Model: Model PE –P1/MF1		Date: 28-Dec-07	No.: RG165001a
Subject: Firmware History - Engine		Prepared by: H.K.	
From: 1st Tech. Support Sec. Service Support Dept.			
Classification:	<input type="checkbox"/> Troubleshooting <input type="checkbox"/> Part information <input type="checkbox"/> Action required <input type="checkbox"/> Mechanical <input type="checkbox"/> Electrical <input type="checkbox"/> Service manual revision <input type="checkbox"/> Paper path <input type="checkbox"/> Transmit/receive <input type="checkbox"/> Retrofit information <input checked="" type="checkbox"/> Other (Firmware History)

Model: Model PE -P1/MF1		Date: 15-Jan-08	No.: RG165002
Subject: Firmware History - Main Control Unit		Prepared by: H.K.	
From: 1st Tech. Support Sec. Service Support Dept.			
Classification:	<input type="checkbox"/> Troubleshooting <input type="checkbox"/> Part information <input type="checkbox"/> Action required <input type="checkbox"/> Mechanical <input type="checkbox"/> Electrical <input type="checkbox"/> Service manual revision <input type="checkbox"/> Paper path <input type="checkbox"/> Transmit/receive <input type="checkbox"/> Retrofit information <input checked="" type="chec

## Replacement of the Image Transfer Belt Unit (pg. 34)

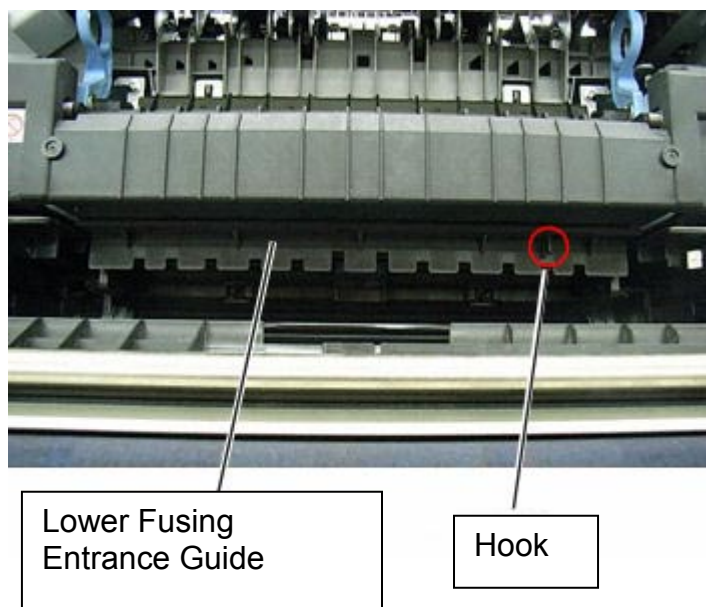
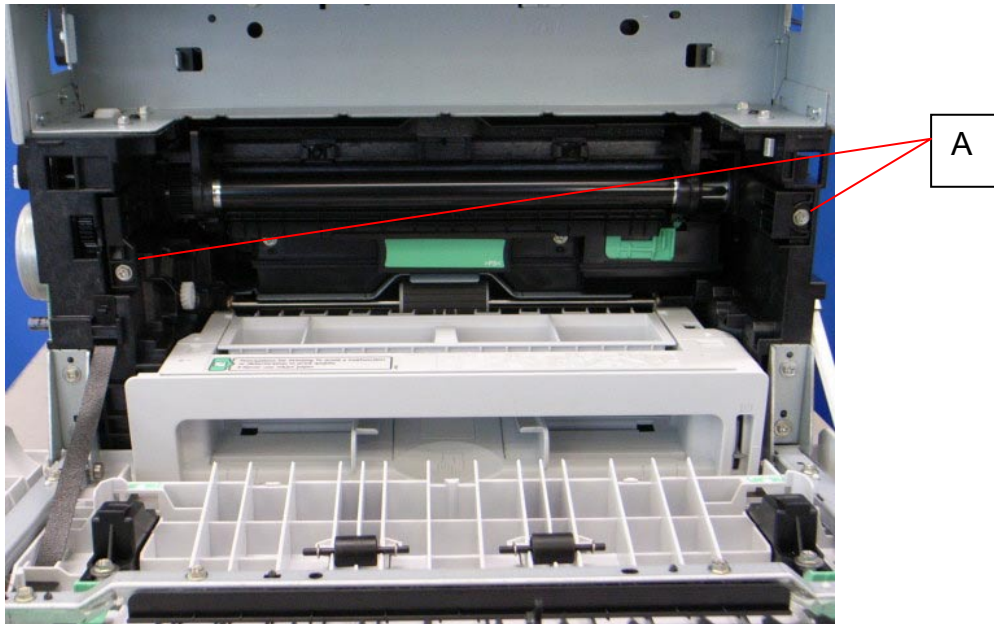
- The old Step 2 was deleted (removing the fusing unit).
- Step 3 below was added (removing the lower fusing entrance guide).

For easier removal, remove the lower fusing entrance guide instead of the fusing unit when removing the image transfer belt.

**3. Remove the lower fusing entrance guide (1 hook).**

Outer exit guide plate:

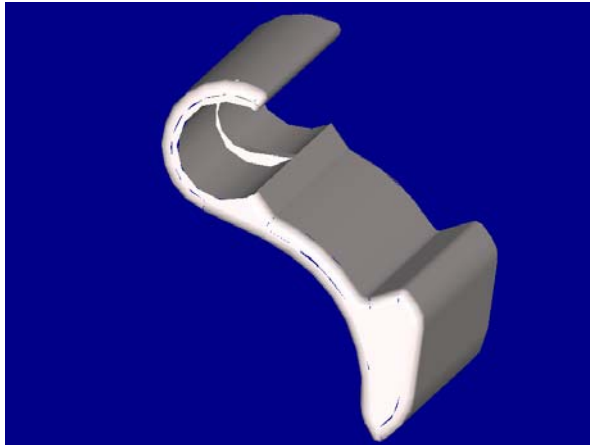
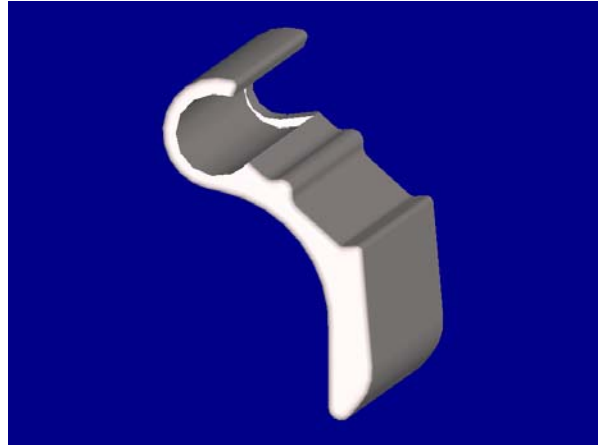
- 1) The pressure of the inner spring was decreased, and the pressure of the outer springs was increased.
- 2) The shapes of the outer exit guide plate and outer exit rollers were changed.
- 3) The shape of the exit rollers was changed (dimension [A] was lengthened, dimension [B] was shortened, and dimension [C] was shortened).
- 4) The exit guide assembly was added.

Exit Rollers:

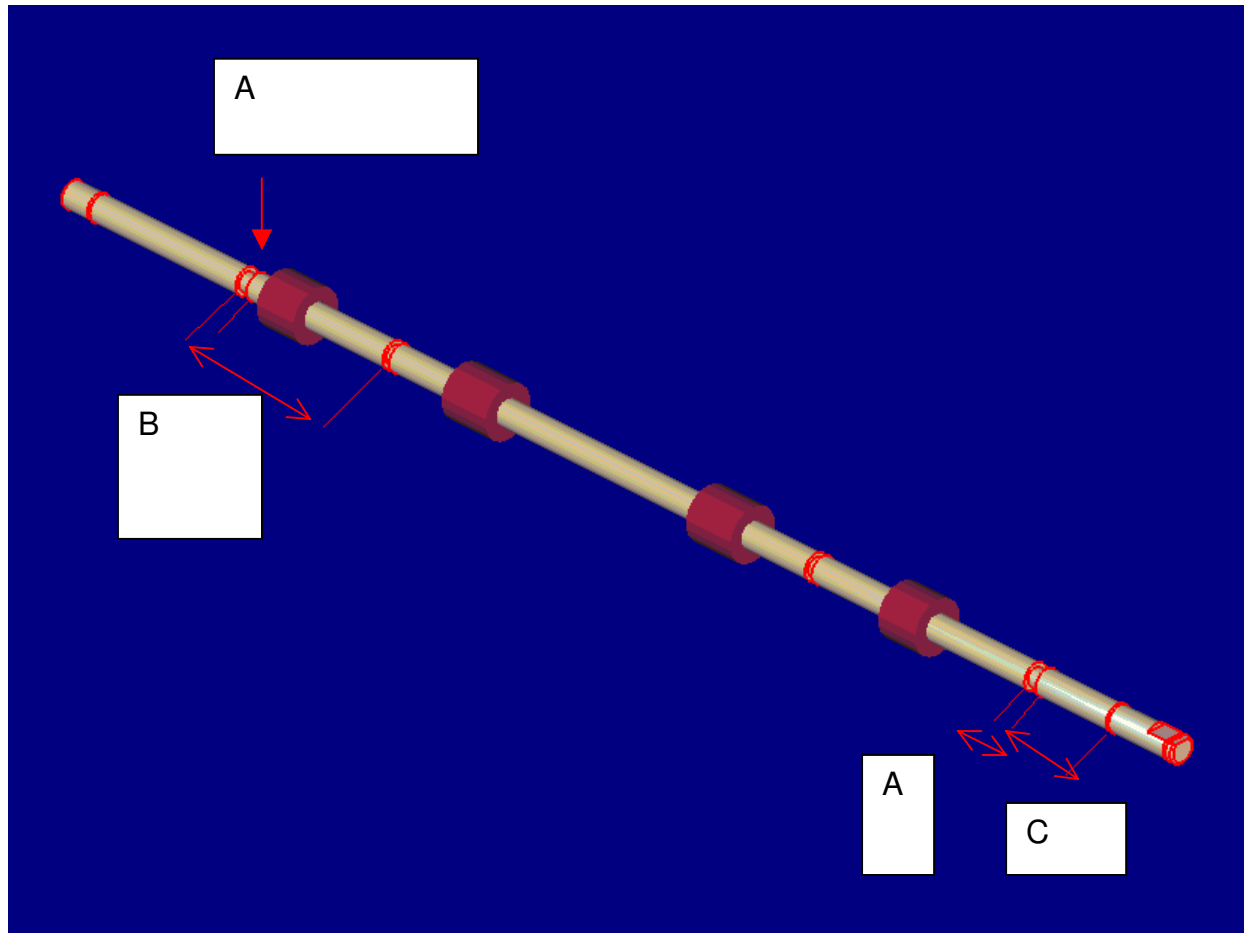
[B]: 246.3 mm to 235 mm

[C]: 28.5 mm to 19

Cover: Base

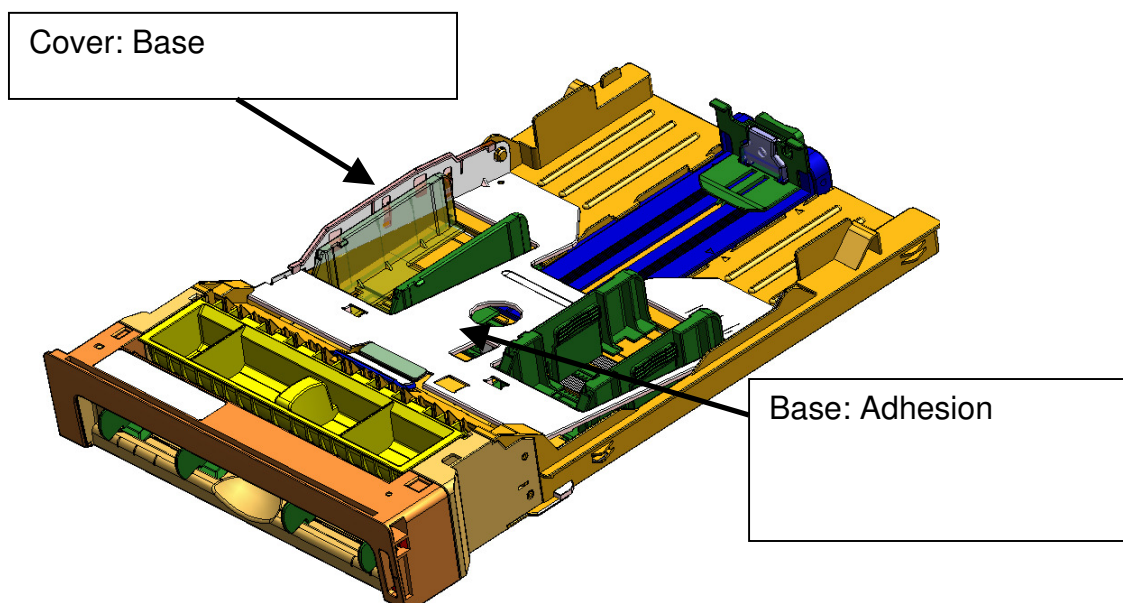
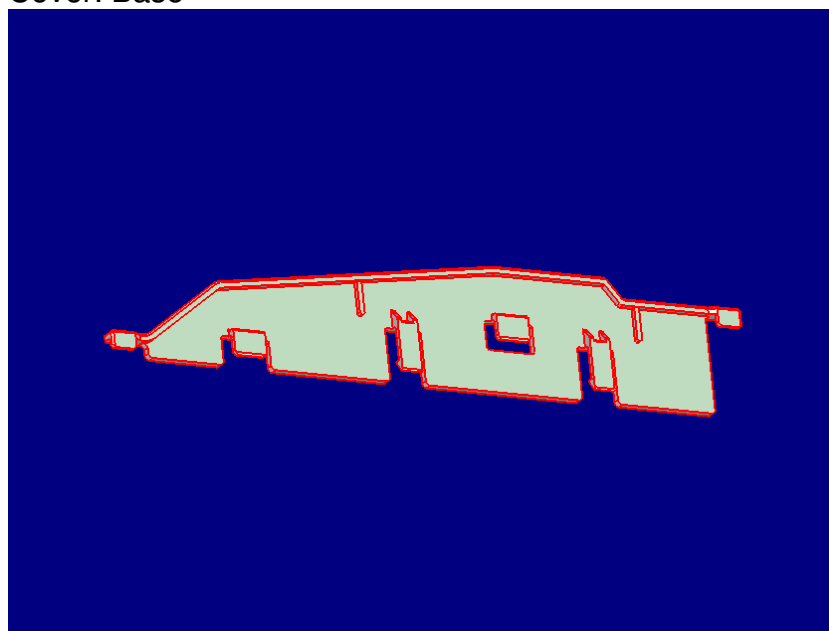
**Change:** The base cover was added (it is connected to the base plate).

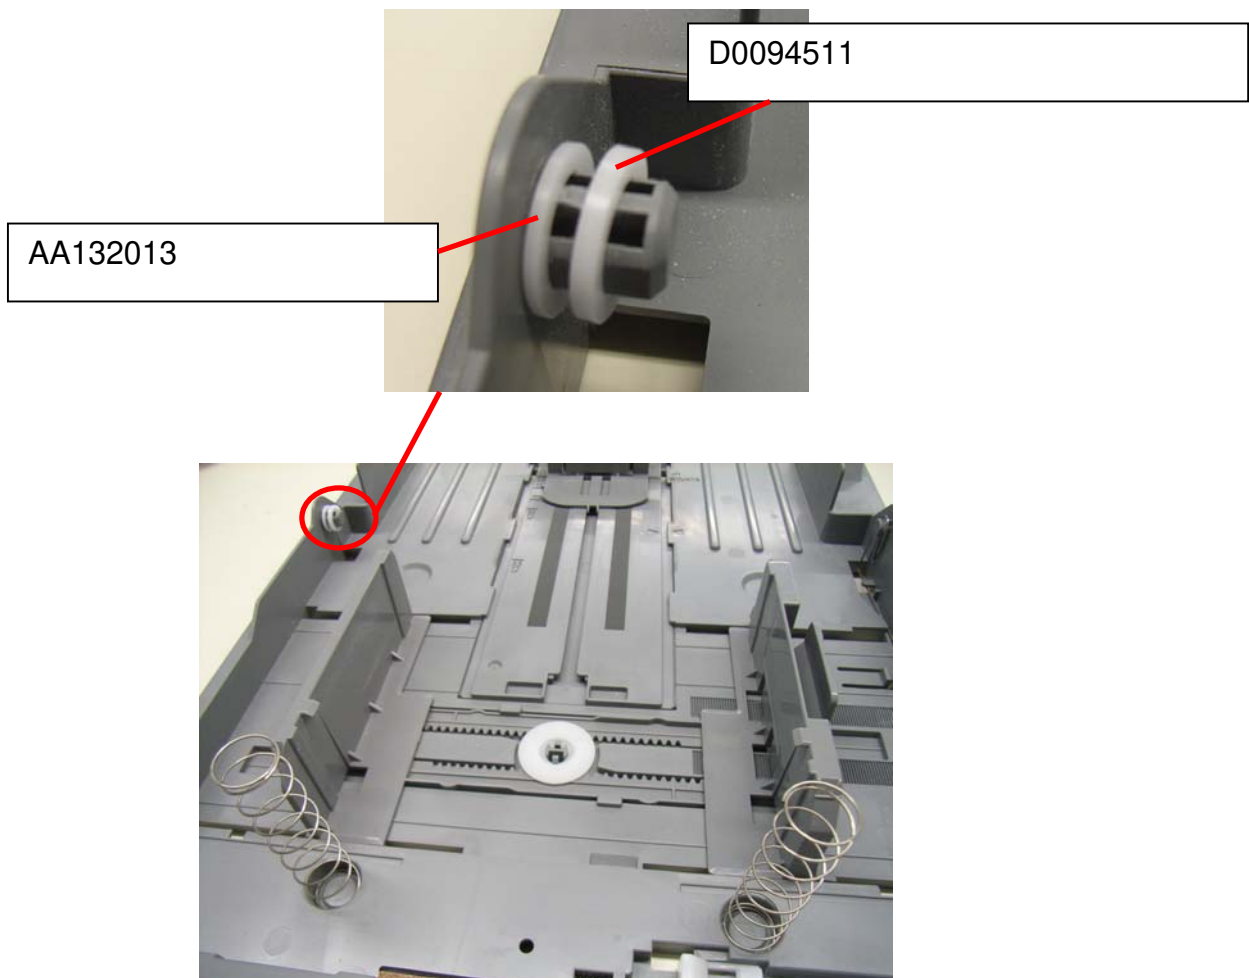
**Change:** Two spacers were added.

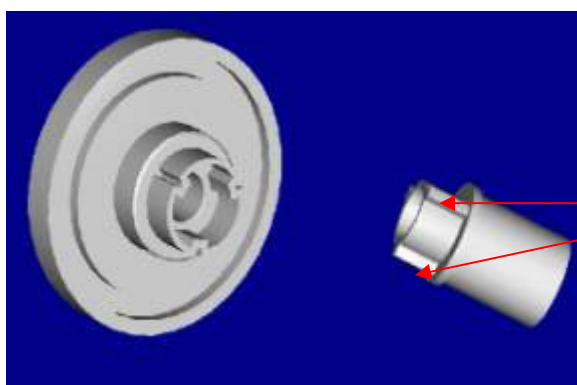
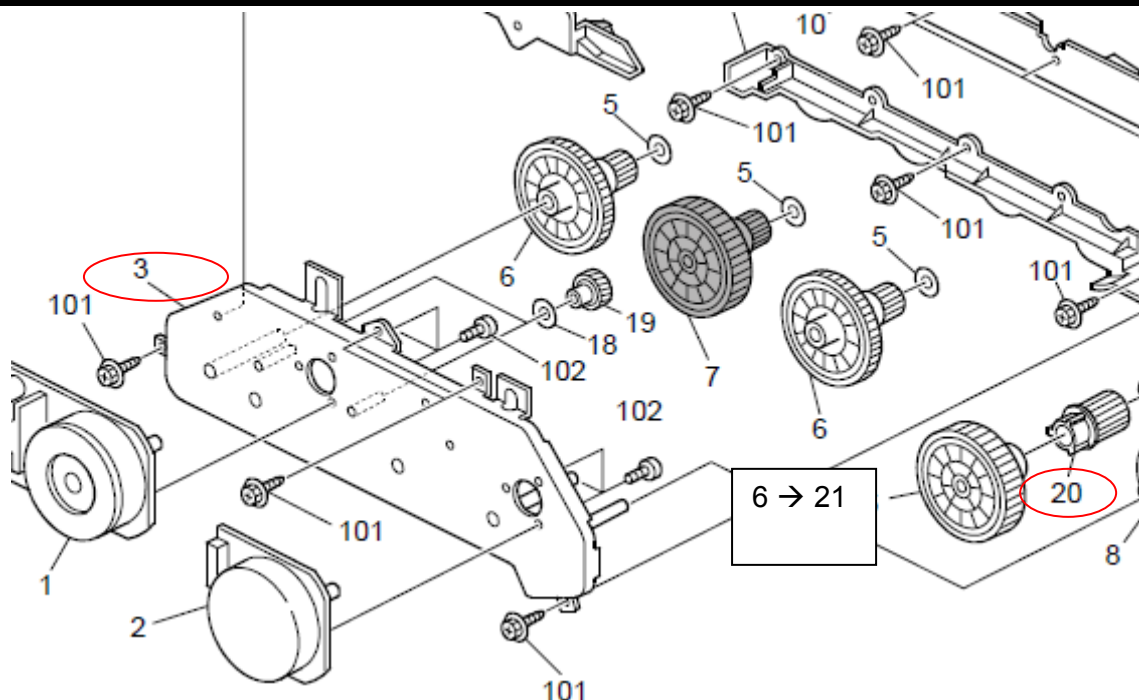
**Change:** Joint gears were added to the black AIO drive section.

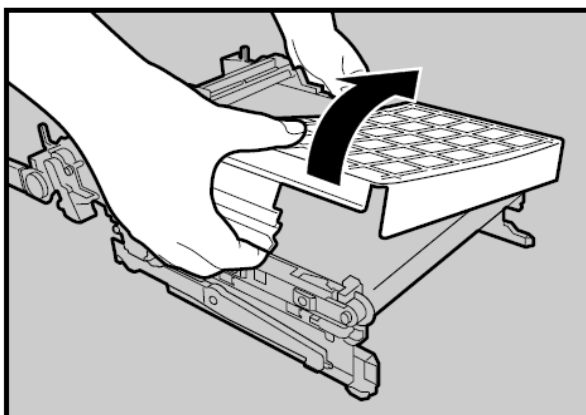
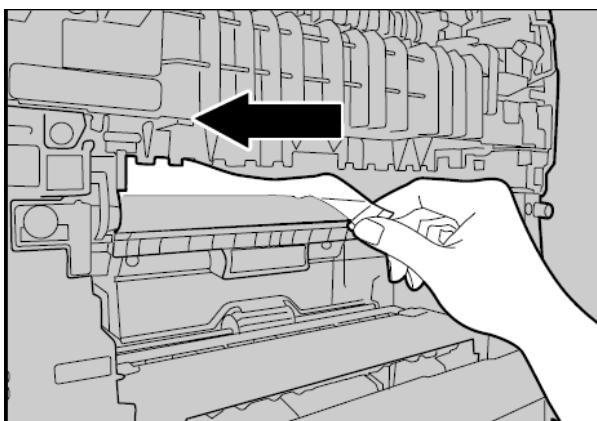
**Change:** Covers were added to the unit.

**Important:** Do the following whenever you replace the ITB in the field.

1. Before you install the new ITB, remove the first cover as shown.

2. After you install the new ITB, remove the second cover as shown.

New Fusing Unit Front Cover

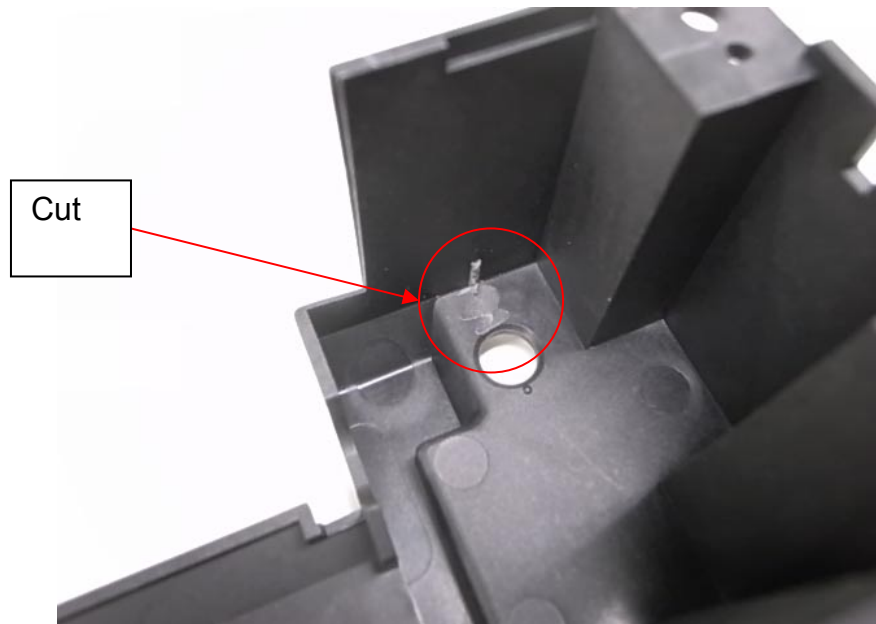
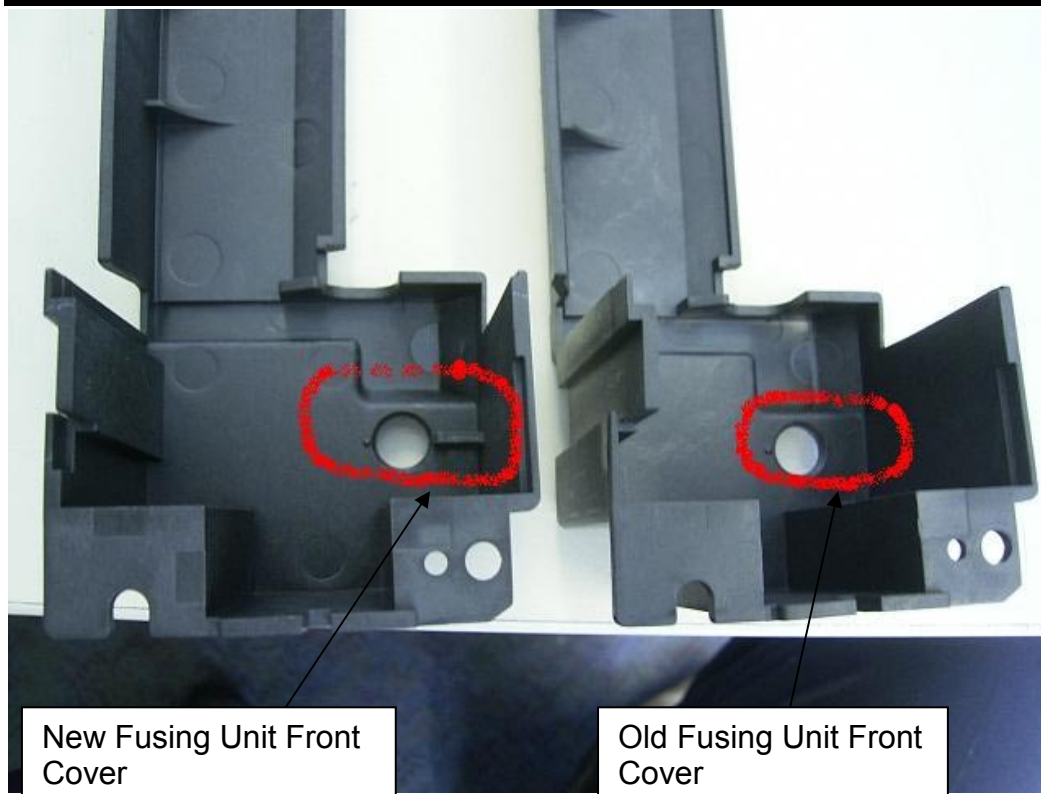
The front cover for the fusing unit (P/N G1664066, pg. 15, index 2) cannot be attached to the fusing unit.

To facilitate assembly on the production line, a rib was added to the front cover and the shape of the release lever was changed (no service P/N change was made). The new front cover for the fusing unit cannot be attached to the old fusing unit.

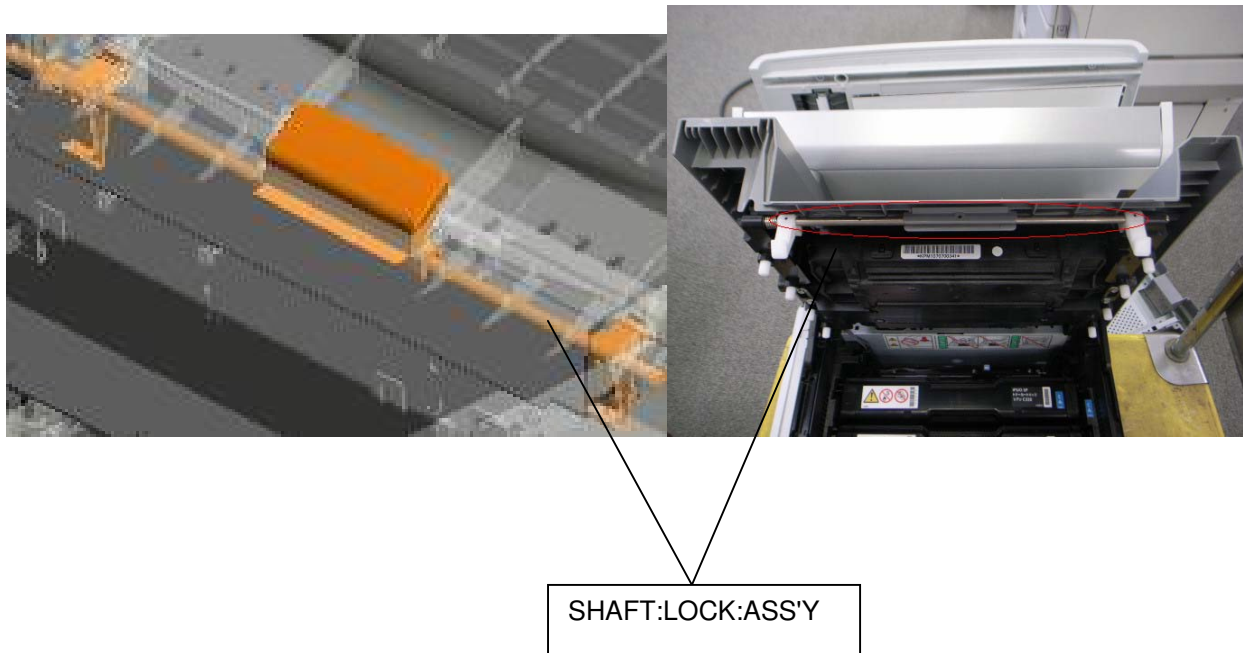
**Change:** The lock shaft was newly registered as a service part.
